30 June 2022

**Re: Design Submission for Ravens Rock Road, Sandyford, Dublin (the “Development”)
(the “Design Submission”) / Connection Reference No: CDS21008079**

Appendix A

TITLE: **PROPOSED FOUL WATER DRAINAGE LAYOUT AT 0 LOWER GROUND LEVEL**

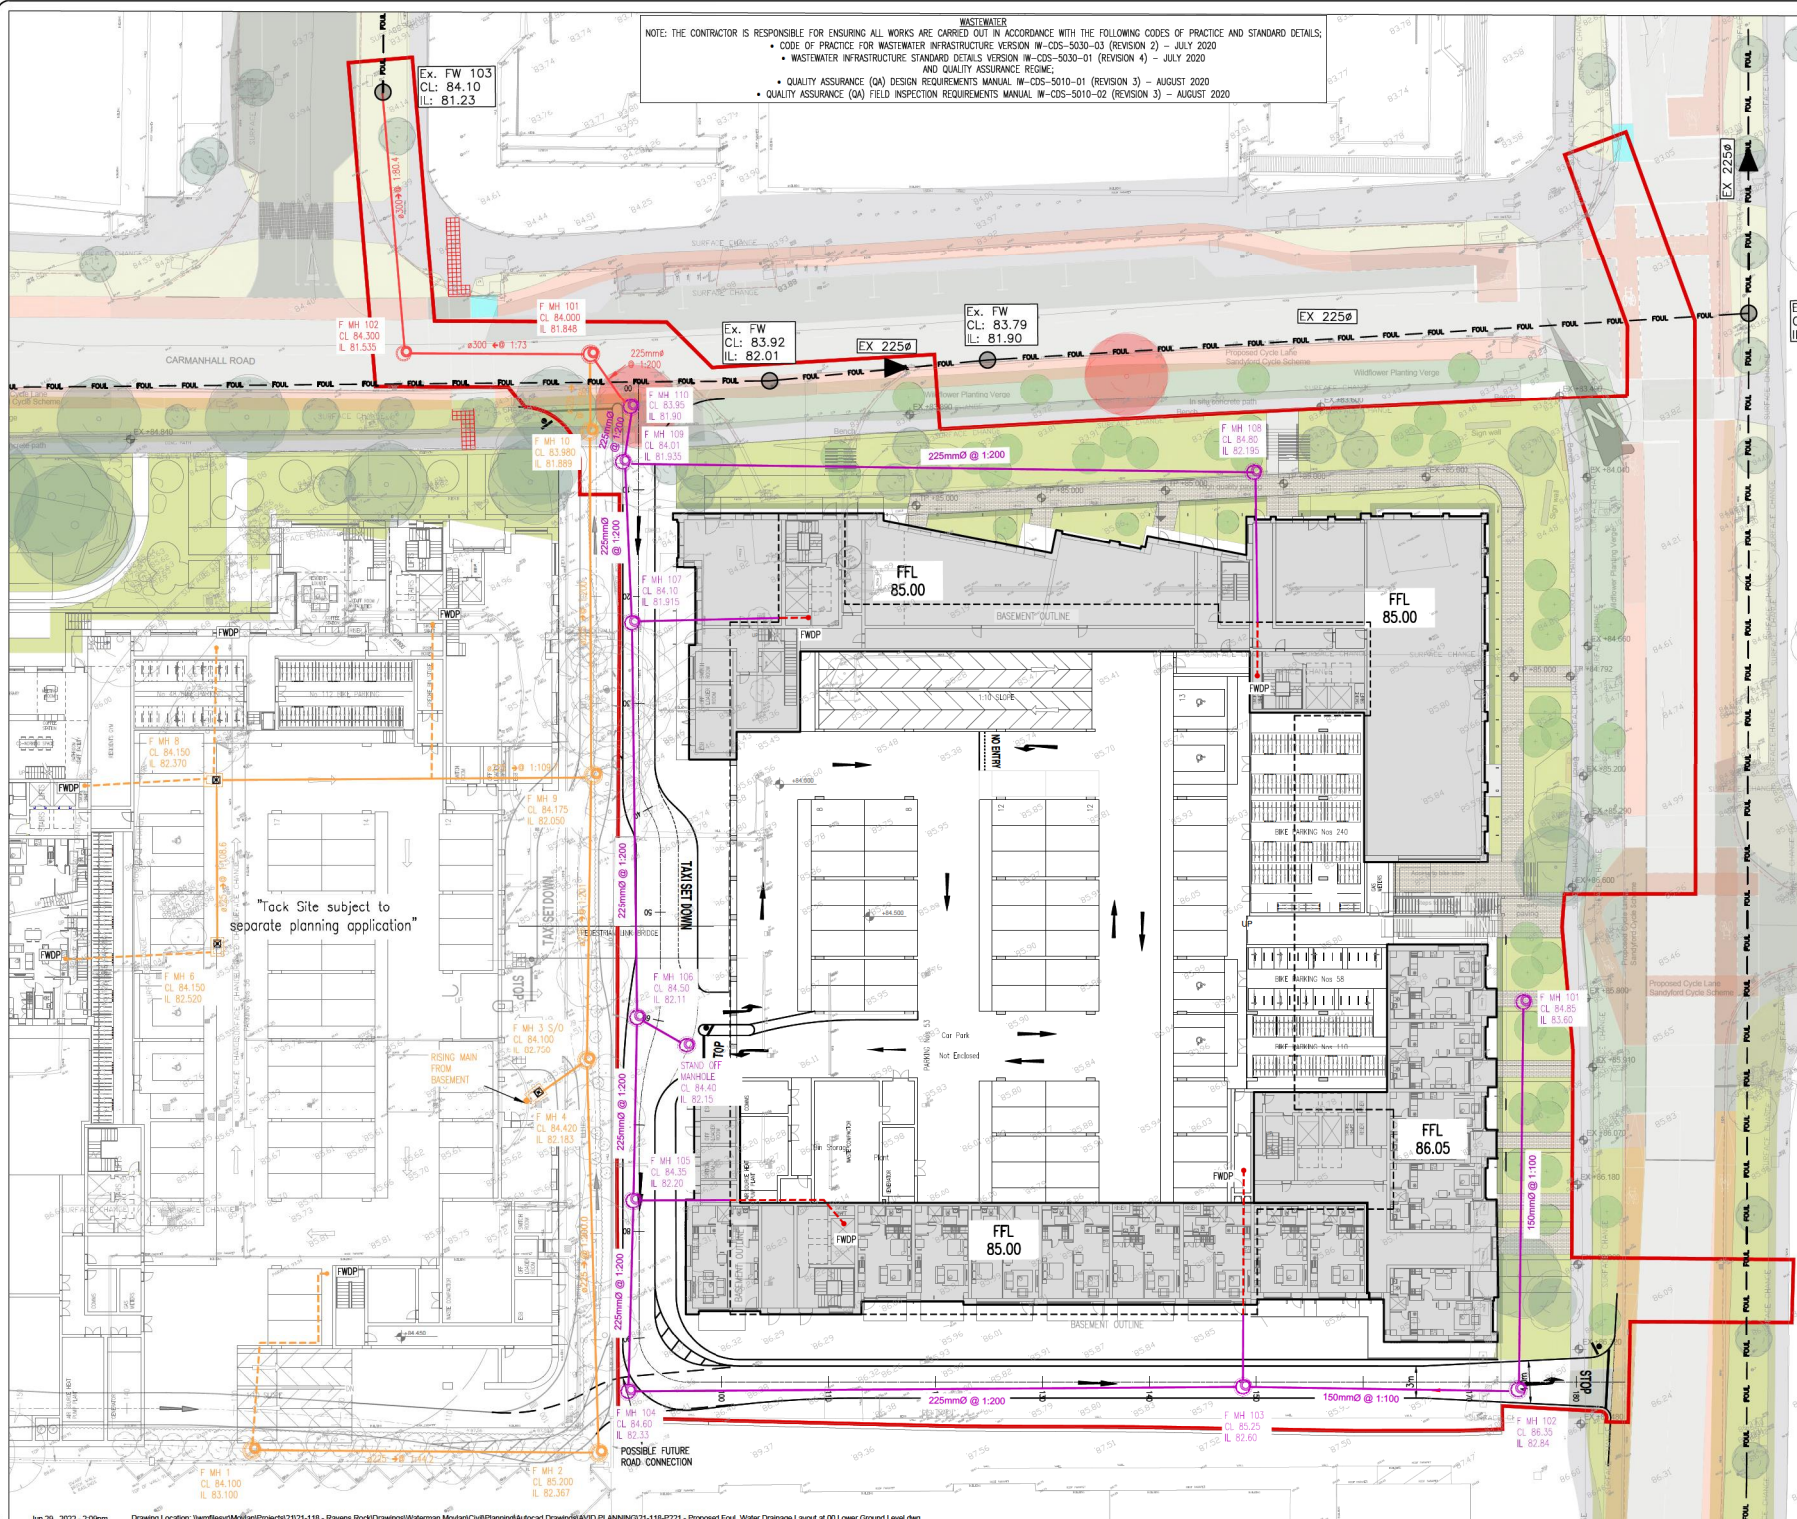
We have reviewed your proposal for the connection(s) at the Development. Based on the information provided, which included the documents outlined in Appendix A to this letter, Irish Water has no objection to your proposals.

The design submission will be subject to further technical review at connection application stage.

This Statement of Design Acceptance is valid for the development over the SHD Avid Site (east side). Previously TACK SHD SODA was issued in April.
